To : ICOM Distributors
 From : ICOM Inc. / CS Department
 Ref No. : ZSM00010
 Date : March 14, 2006

IC-7000 : Stop the AF 8 kHz Tone Noise

To : ICOM Distributors
From : ICOM Inc. / CS Department
Ref No. : ZSM00010
Date : **May 12, 2006**

<IC-7000 LOGIC UNIT : TOP VIEW>

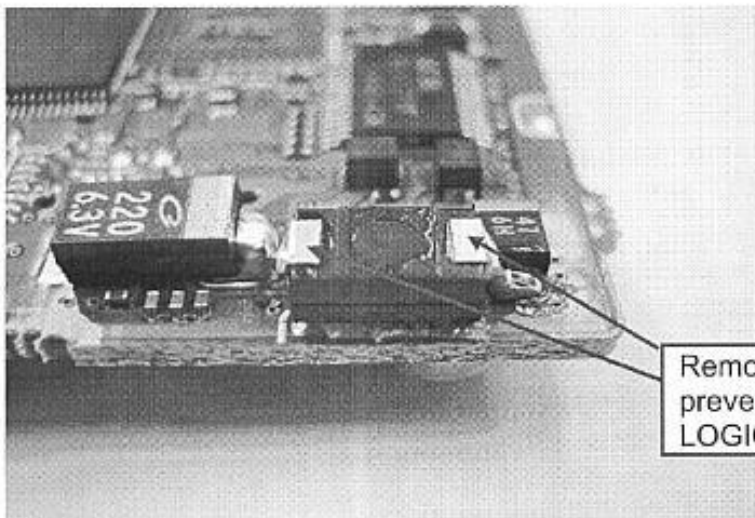
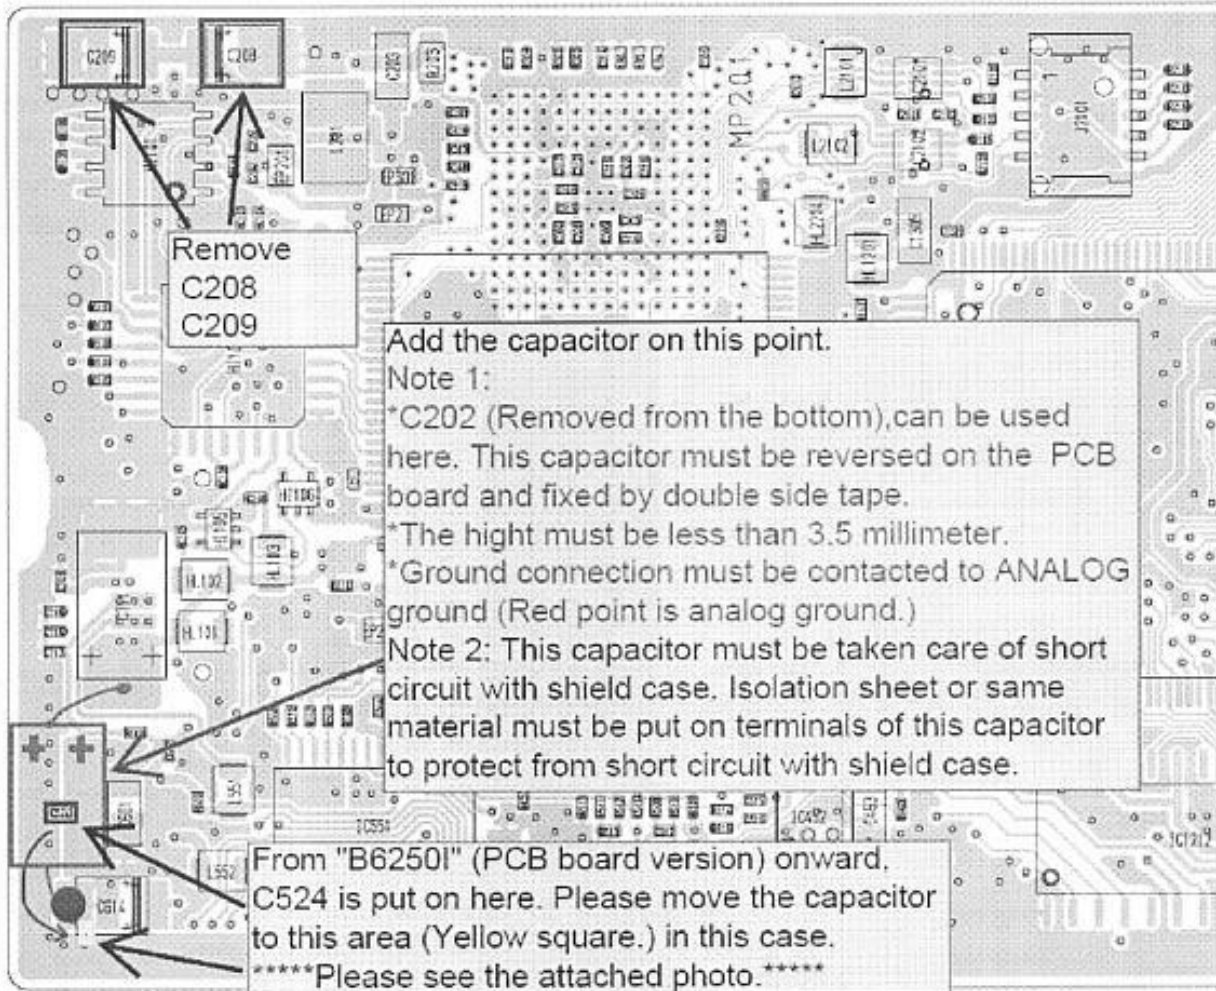
Some IC-7000 transceivers may have the symptom of 8 kHz Tone Noise in AF. This noise appears when hearing AF with headphone. From Rear EXT SP jack, stronger noise appears compared to FRONT PHONE/SPEAKER jack. The following is how to stop this noise.

1. Model IC-7000
2. How to improve Change the location of capacitors
3. Replace parts Remove capacitors from LOGIC UNIT

Ref. NO.	Part NO.
C207	4030018960 C3216 JB 1C 106MT-N
C208	4550006780 TEESVB2 0J 476M8R
C209	4550006780 TEESVB2 0J 476M8R
C202	4550007310 F930 J227MNMBMA
(Replace)	Replace C202 form the bottom → top of the LOGIC UNIT

From PCB boards' version "B6250K" onward, all LOT are manufactured according to this modification. Serial number has not yet been fixed. We will announce when S/N is fixed.
